Project No. W1547-06-01 *Revised May 8, 2023*

Subject: RESPONSE TO SOILS REPORT REVIEW LETTER

PROPOSED CHAMINADE HIGH SCHOOL IMPROVEMENTS 7500 N. CHAMINADE AVENUE, 23241 W. COHASSET STREET,

City of Los Angeles Geology and Soils Report Review Letter, Log No. 124921, dated

Figure 1, Site Plan

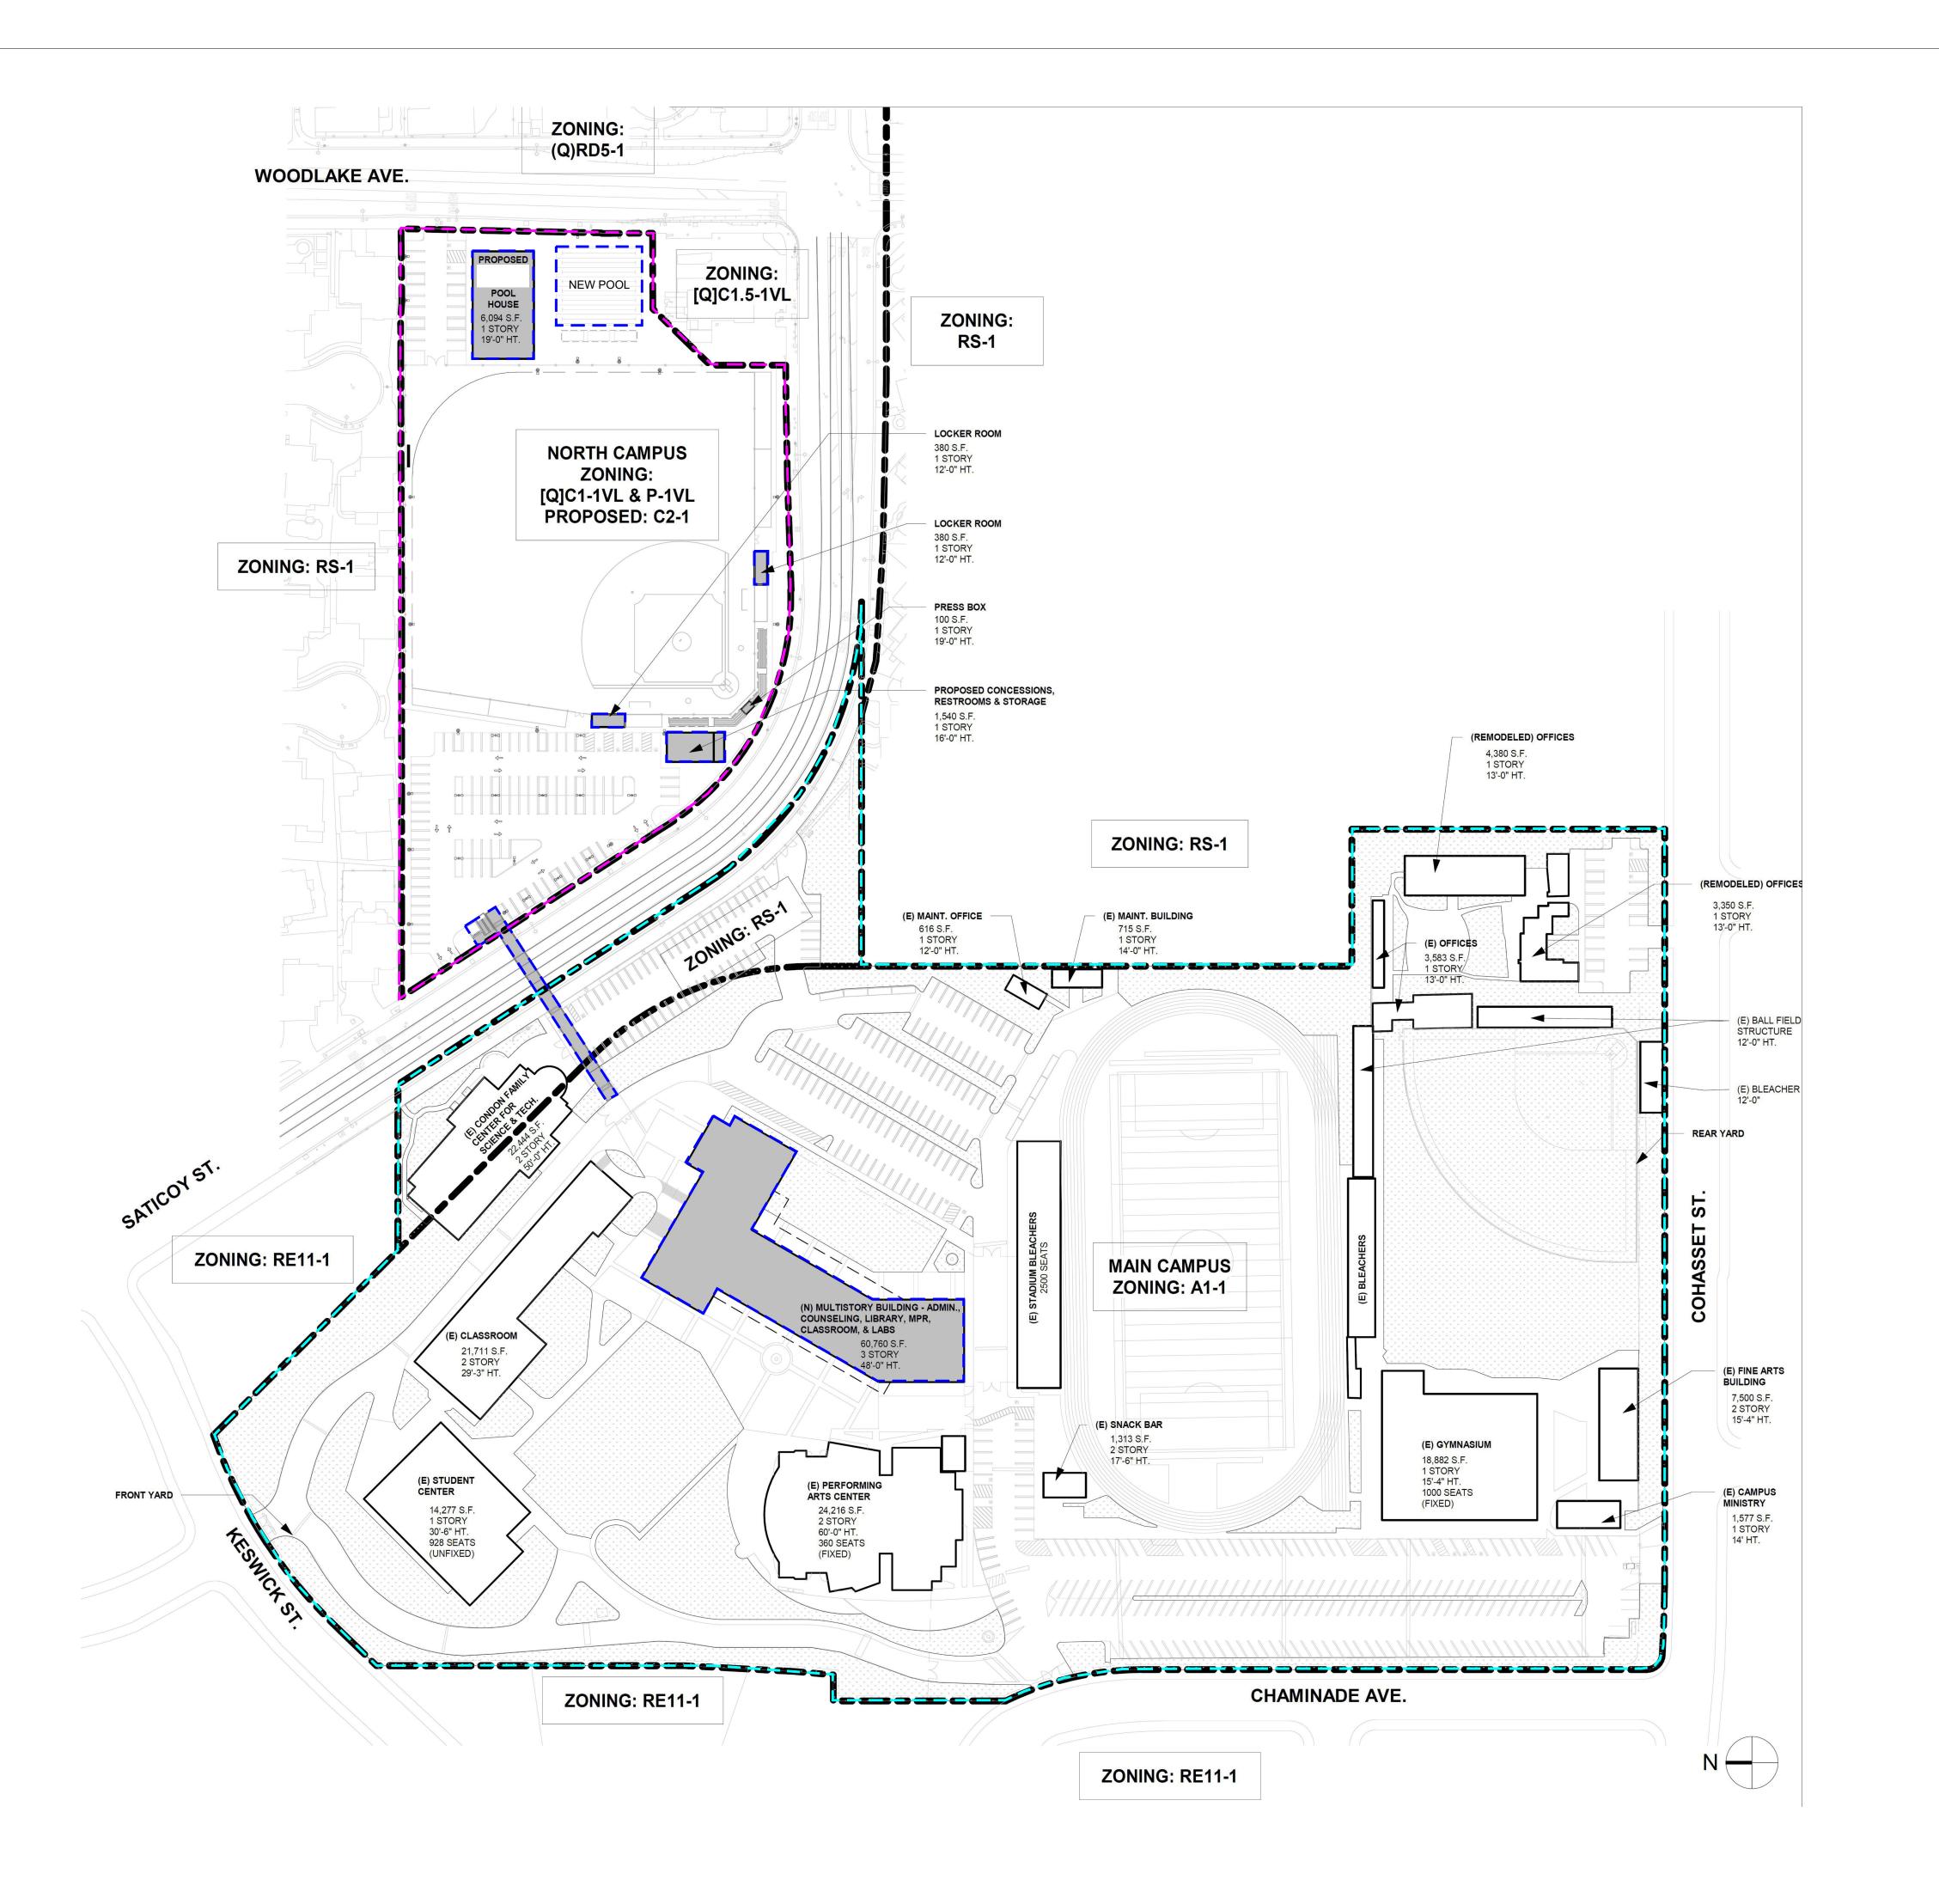
Based on discussions with the client and review of the conceptual project plans, the project scope has been revised and no longer includes the Main Campus gymnasium nor the North Campus parking structure. A revised project description is included below.

The locations of the proposed improvements are shown on the updated site plan (see Figure 1). The recommendations of the January 12, 2023, report remain applicable to the project as presently proposed. Where differing, recommendations in this response letter supersede those presented in the referenced report and should be utilized for design and construction.

GEOLOGIC MAP (MAIN CAMPUS)

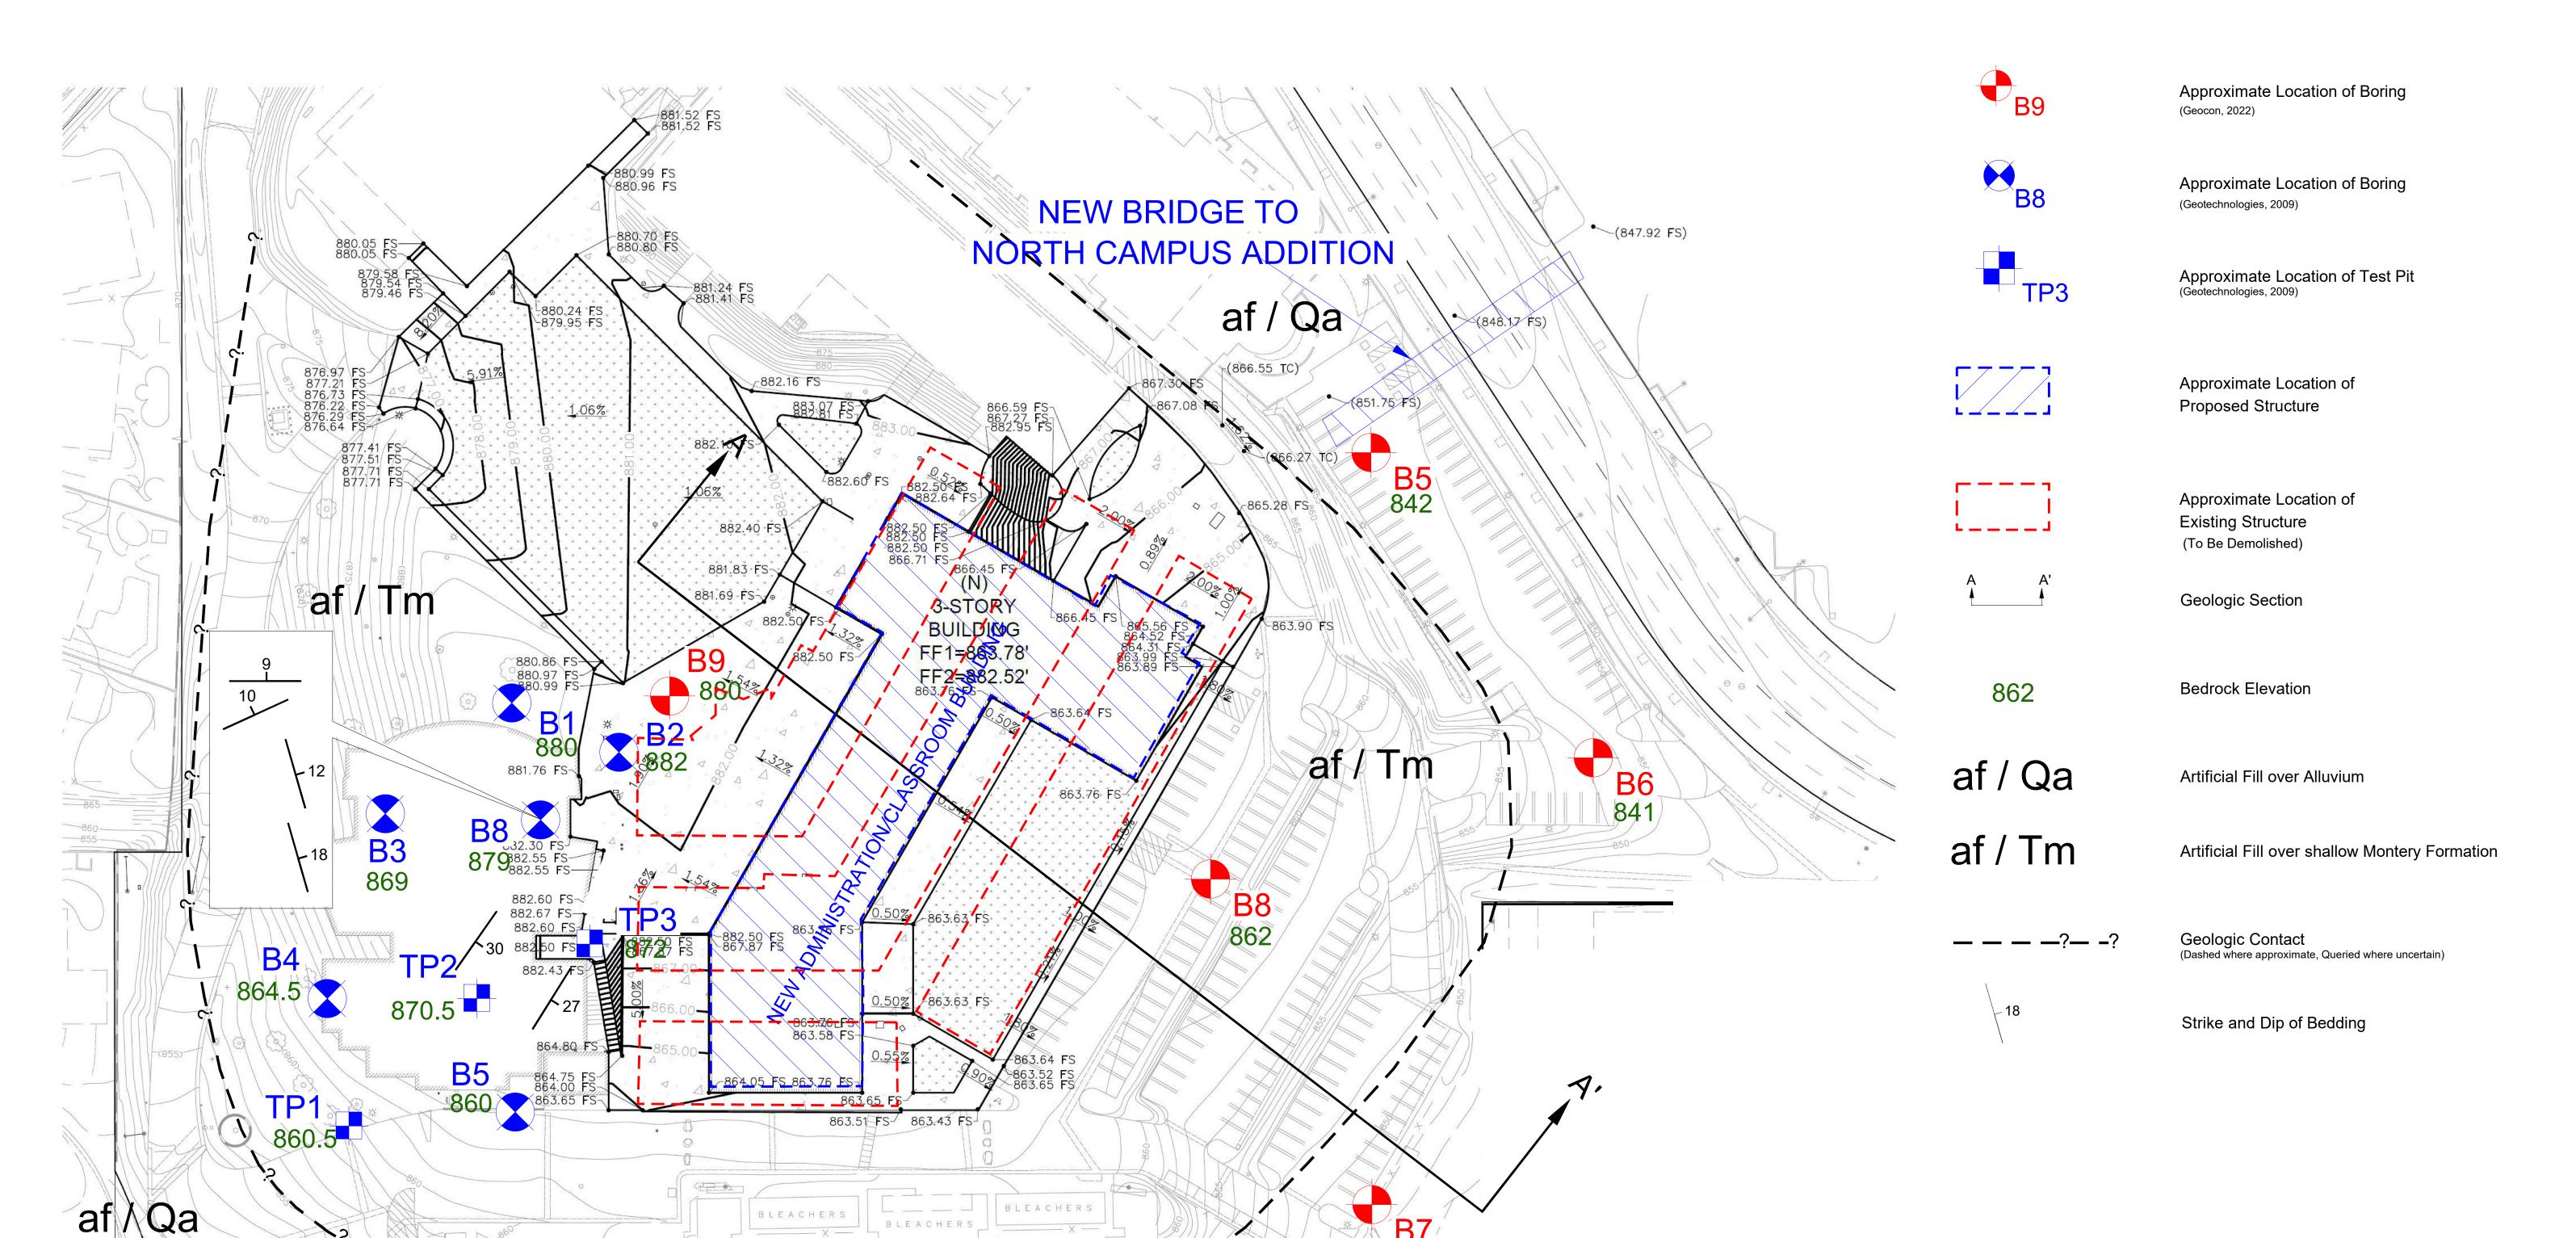
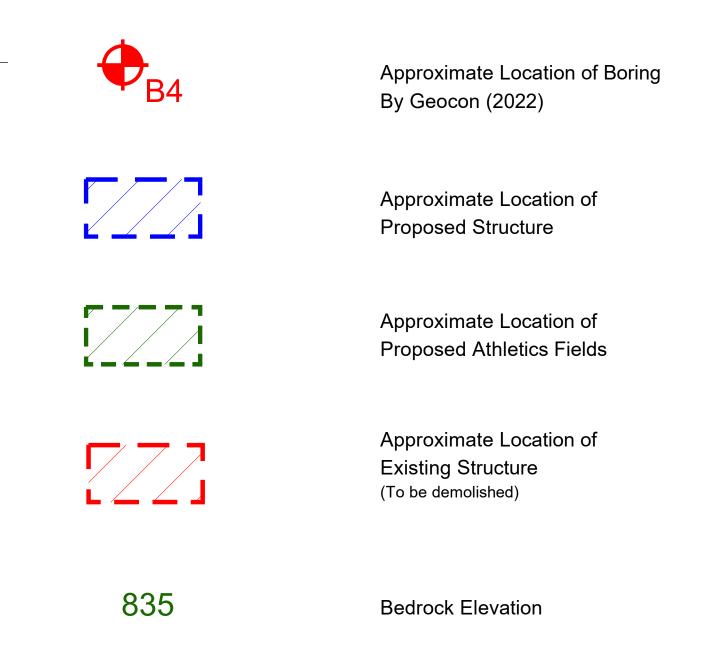
- Comment 2: Provide a geologic map that is based upon conceptual grading or site development plans, to illustrate all proposed and existing contours relative to the planned grading and/or construction, along with all off-site slopes and conditions that could adversely affect the stability or safety of the site (7006.3.2).

- Comment 3: Show the location and height of all proposed retaining walls.

- Comment 4: Verify the location of the borings on the maps and cross sections, and revise accordingly.
- **Response 4:** Boring Locations have been reviewed and are correctly located on the Geologic maps and cross sections (see Figures 2A, 2B and 3).

- Response 2: A Geologic Map of the Main and North Campus is provided on Figures 2A and 2B, respectively. Artificial fill is the surface material at the site and is underlain by either Holocene age alluvium or Tertiary age bedrock of the Monterey Formation. The geologic units are designated as artificial fill over alluvium (af/Qa) or artificial fill over shallow Monterey Formation (af/Tm).

- Response 3: The Geologic Maps use the conceptual site grading plans as a background which indicate the proposed retaining wall locations and heights. The only proposed retaining wall will be the basement walls of the proposed Administration/Classroom Building where the northwest (southeast-facing excavation) may expose unsupported bedding in the lower 5 feet of the building excavation (see Figure 2). Temporary shoring and retaining wall recommendations to support adverse bedding conditions are provided in the January 12, 2023 report.
